City Council Staff Report

Consideration of an Ordinance rezoning approximately 4.06 acres from Agricultural-Residential (A-2) to Residential-Minor Agricultural (RA-2) located at approximately 440 West 1400 North and approving the Preliminary Plat for the Hidden Lane Estates Subdivision Plat "A" consisting of eight lots.

MAPLETON CITY DEVELOPMENT REVIEW COMMITTEE MINUTES

On April 30, 2019, Murdock Builders submitted new plans for the Hidden Lane Estates Subdivision, Plat A in the A-2/RA-2 zone and located at approximately 440 West and 1400 North. The items below include 1) requested changes to the submitted plans, 2) other items required as part of the application and/or 3) informational items regarding city standards. **All items that include an * and are bolded are required prior to any public hearings.**

HIDDEN LANE ESTATES PLAT "A"

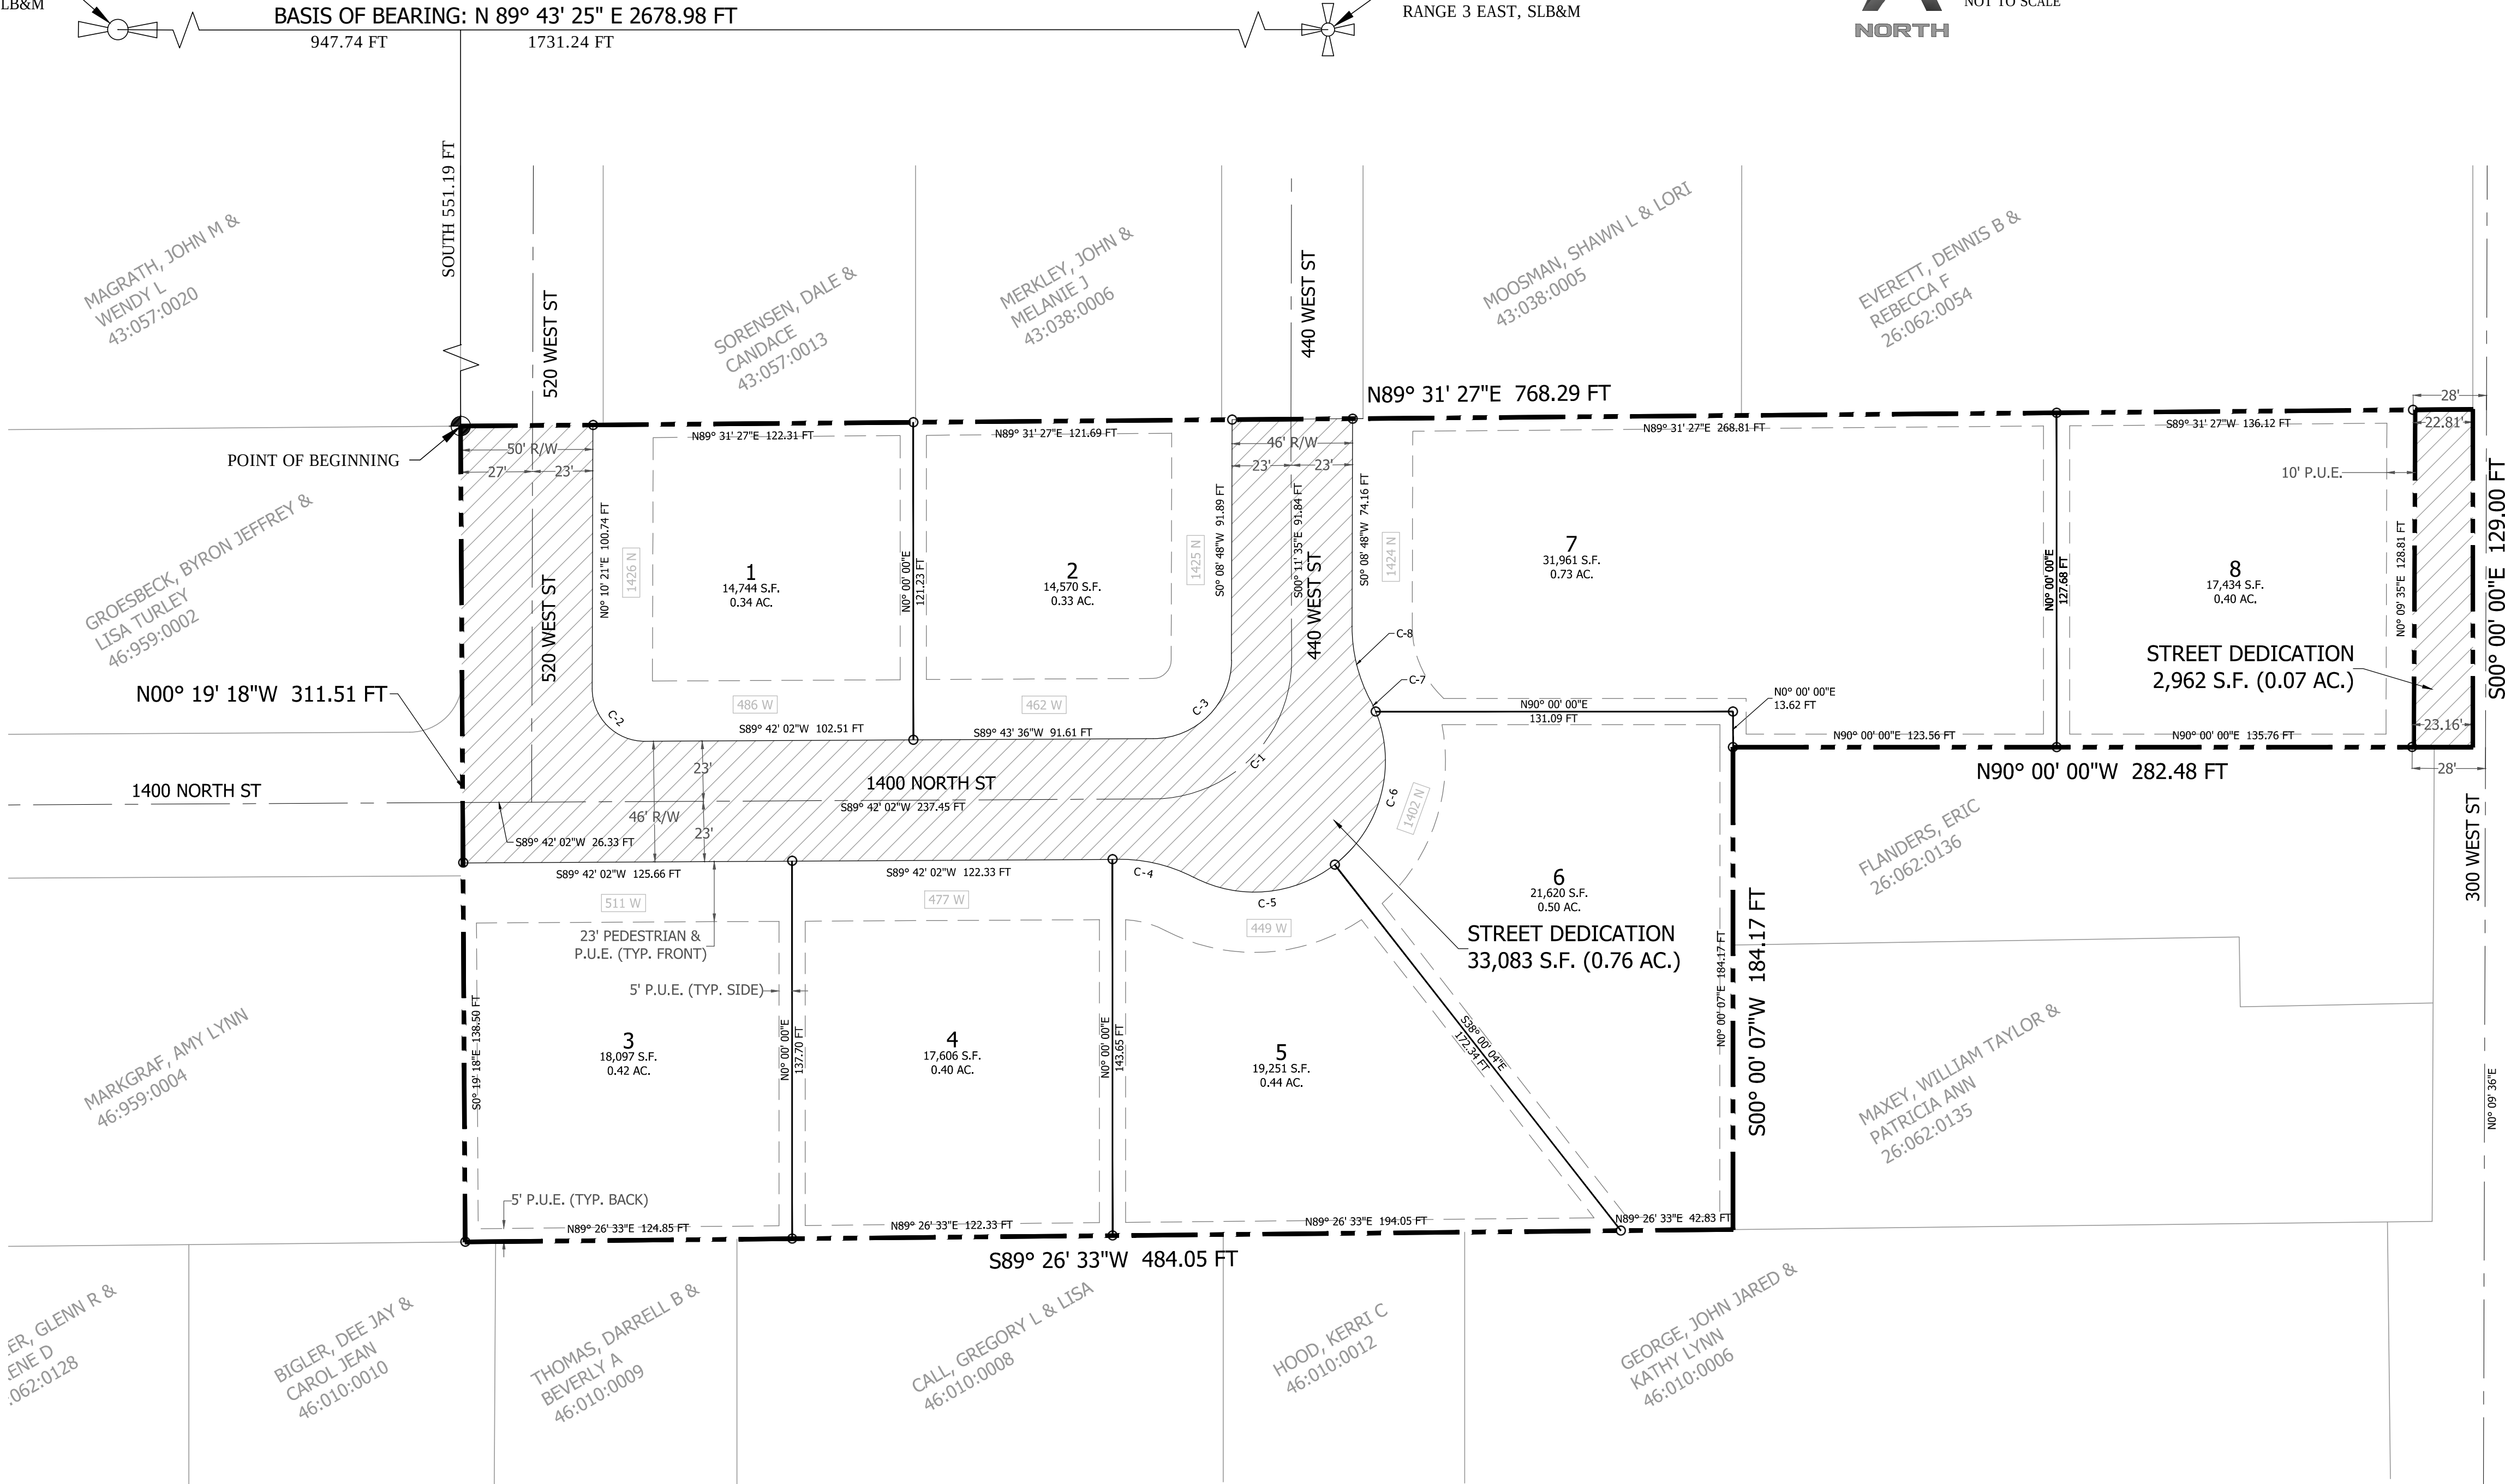
1. **Lots 1 and 2 do not contain the required 14,500 square feet. The subdivision cannot be approved until the lots meet the minimum area requirement.***

2. The final plat must include, among other requirements, the following:
 - a. A final plat stamped and signed by the Surveyor of Record.
 - b. A dedication block and signature lines for all property owners. The owners will need to sign the plat exactly as they signed the deed to the property and must print their names underneath their signatures to match the signatures. In addition, properties in trusts must include the title of the signer, the full name of the trust and the date of the trust.

- c. The owners dedication must be accompanied by a line for the notary sign the plat, a line for the notary to print their full name, their commission number and the words "A notary public commissioned in Utah" in the signature block.

- d. Addresses must be shown on the final plat. The assigned addresses are attached to these DRC minutes.
 - e. Street coordinates must be shown on the plat. If street names are to be used they must also be indicated on the plat

- f. In accordance with the standards of the Utah County Recorder, a space must be reserved near the bottom right hand corner for the recording certificate to be printed

on the plat. The current plat doesn't make enough space for this certificate and the space provided is not in the correct location. Please communicate with the Utah County Recorder's Office for the specifics for this requirement.

- g. In accordance with the standards of the Utah County Recorder, the names of the Owners must be printed in the Acknowledgement as the persons who appeared before the notary. It is useful for the plat to contain a space within the acknowledgment text for the names to be written. Other standards may apply for trusts and corporations. Please communicate with the Utah County Recorder's Office for the specifics for this requirement.
3. Boundary line gaps exist along the south and east property lines. These need to be resolved prior to recording the plat.
4. The applicant must show that lots 3 and 5 meet the minimum width requirement of 100'. The width measurement is made at the building line. The front yard setback is 30'. Provide a diagram with a measurement that shows that the minimum width is met at the setback/building line.

HIDDEN LANE ESTATES PRELIMINARY PLAT

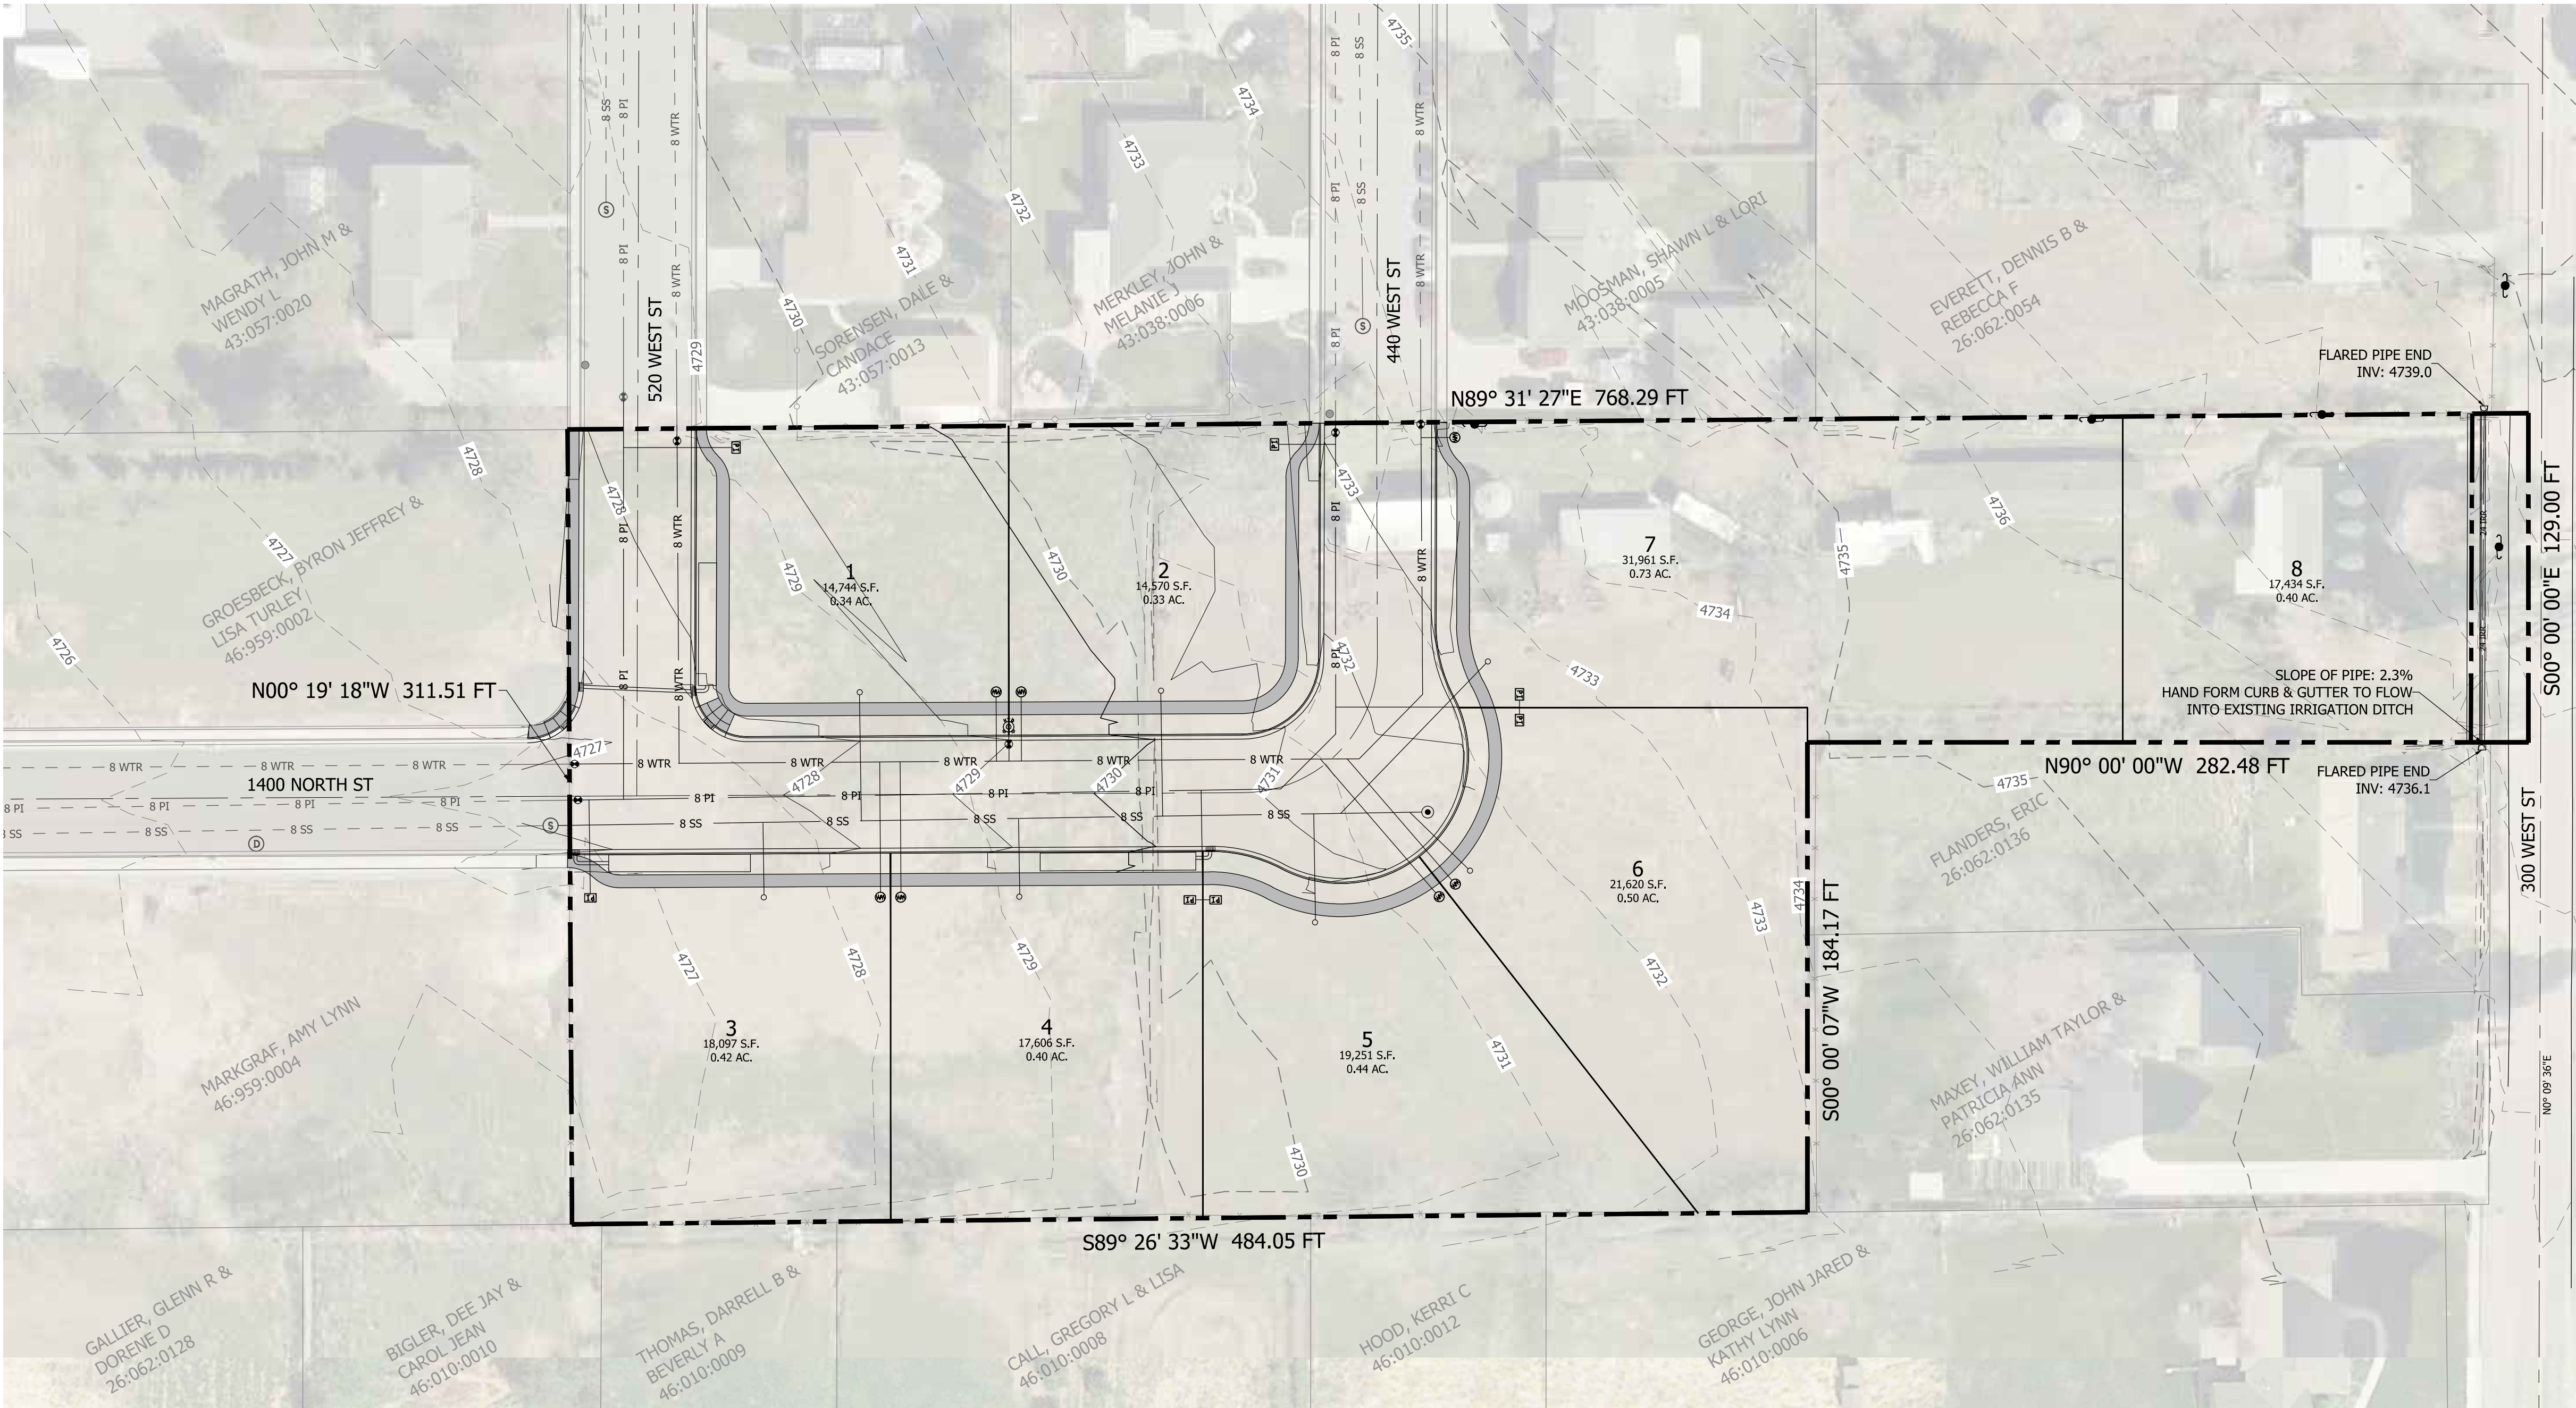
1. Please show pressurized irrigation system.

1. Please use updated city standard drawings.
2. Please remove typical pedestrian ramp detail and refer to latest APWA standards.
